Access Compliance Report Public Rights-of-Way (Curb Ramps)

Main Street: DANA_DR Cross Street: ISLAND_WAY Location: N

ADA ID: RPRK220221161230 Ramp Type: Type 1 - Perpendicular Diagonal Initial Pass/Fail: Pass Overall Compliance: No Severity Score: 19

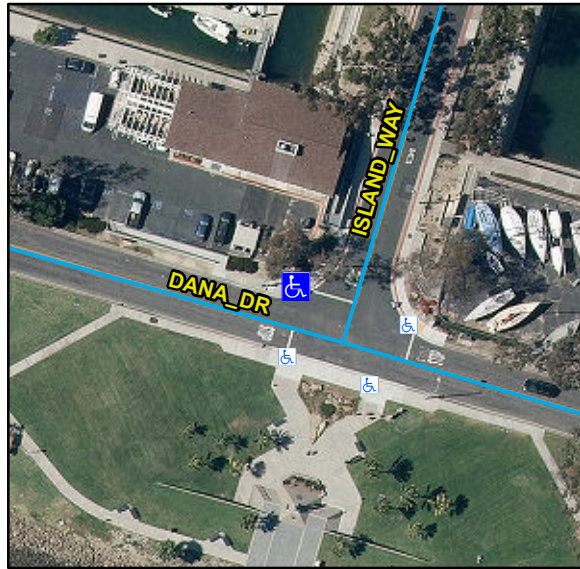
Compliance	Description	Data	Compliance	Description	Data
N/A	Ramp Length (in)	72	N/A	Flare Type LT	
No	Ramp Width (in)	47			Sloped
Yes	Ramp Run Slope (%)	6.1	Yes	Flare Slope LT (%)	3.6
Yes	Ramp Cross Slope (%)	0.6	N/A	Flare Traversable LT	Yes
N/A	Landing Present	No	N/A	Flare Type RT	
N/A	Landing Length (in)	N/A			Sloped
No	Landing Width (in)	N/A	Yes	Flare Slope RT (%)	3.4
No	Landing Run Slope (%)	N/A	N/A	Flare Traversable RT	Yes
No	Landing Cross Slope (%)	N/A	Yes	DWS Provided	Yes
N/A	Landing Movement Obstructed?	N/A	Yes	DWS Contrast	Yes
	Landing Movement Type	N/A	Yes	DWS Length (in)	36
N/A	Landing Shared	N/A	Yes	DWS Full Width	Yes
N/A	Clear Space	Yes	Yes	DWS Offset Left (in)	0
N/A	Clear Space To Crosswalk (in)	48	Yes	DWS Offset Right (in)	N/A
N/A	Marked Crosswalk 1	No	N/A	Marked Crosswalk 2	No
	Crossing 1 Direction	SW		Crossing 2 Direction	SE
	Marked Crosswalk 1 Width (in)	N/A		Marked Crosswalk 2 Width (in)	N/A

N/A	Ramp Inside Crosswalk 1	N/A	Yes	Ramp Inside Crosswalk 2	N/A
	Crossing 1 Slope (%)	0.1		Crossing 2 Slope (%)	0.1
	Crossing 1 Cross Slope (%)	0.6		Crossing 2 Cross Slope (%)	0.2
Yes	Gutter Ponding	No	N/A	Curb Slope	0.9
Yes	Gutter Lip Height (in)	0		Road Run Slope (%)	0.2
No	Gutter Run Slope (%)	6.2		Road Cross Slope (%)	0.3
Yes	Gutter Cross Slope (%)	1.1			
Yes	Overall Surface Condition: Acceptable		Yes	Perp Joint Present	Yes
	Cross Gutter Present?	No		Spandrel Present?	No
	Replace Cross Gutter?	N/A		Replace Spandrel?	N/A

Remove & Replace Curb Ramp With Two New Directional Ramps or Equivalent. Remove & Replace Gutter.
